*Proposed extension
41 Wearside Drive
Durham DH1 1LE
For Mr & Mrs McConway*

Proposed layout

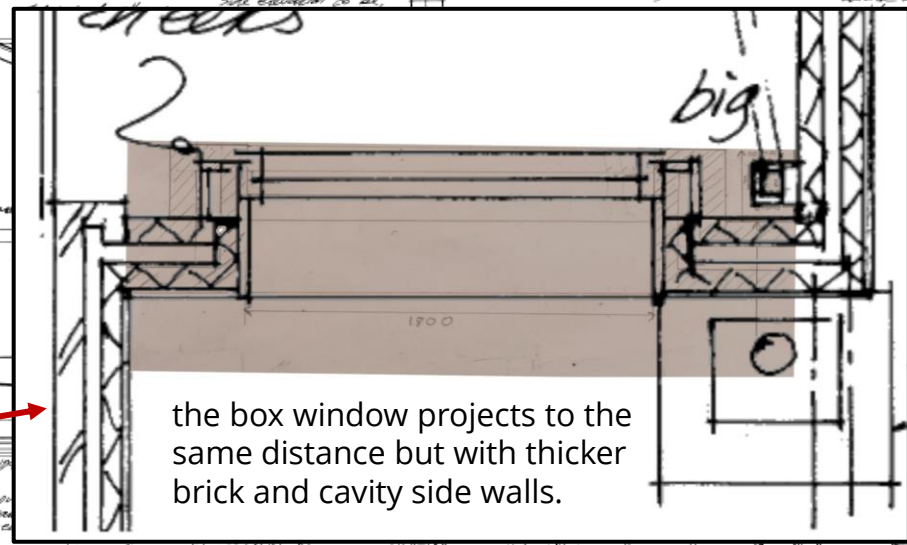
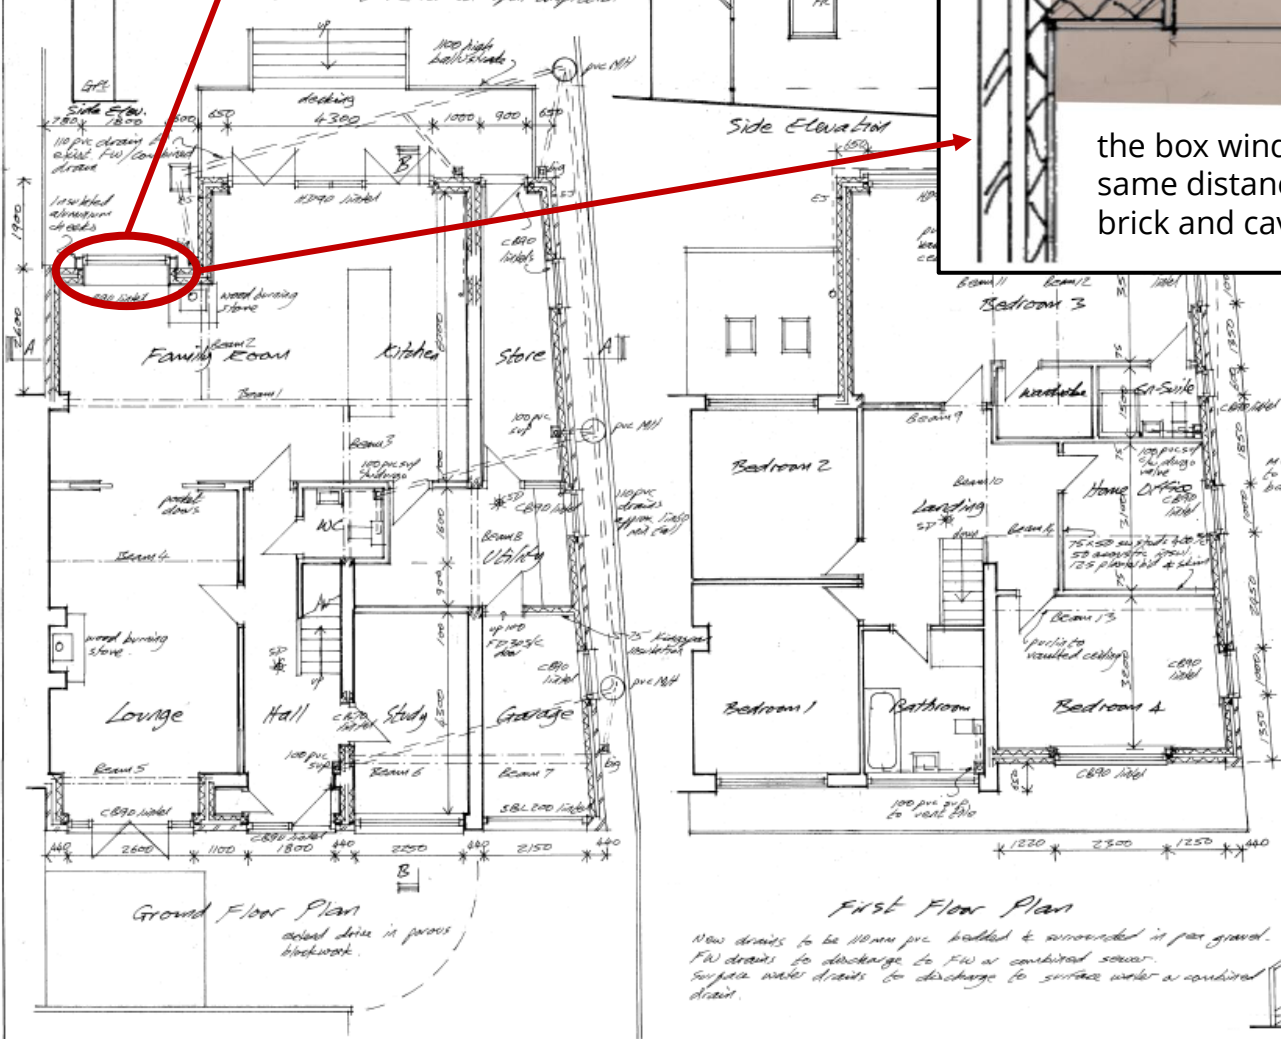
Proposed change, detail:

Proposed change overlaid on this drawing:

the box window projects to the same distance but with thicker brick and cavity side walls.
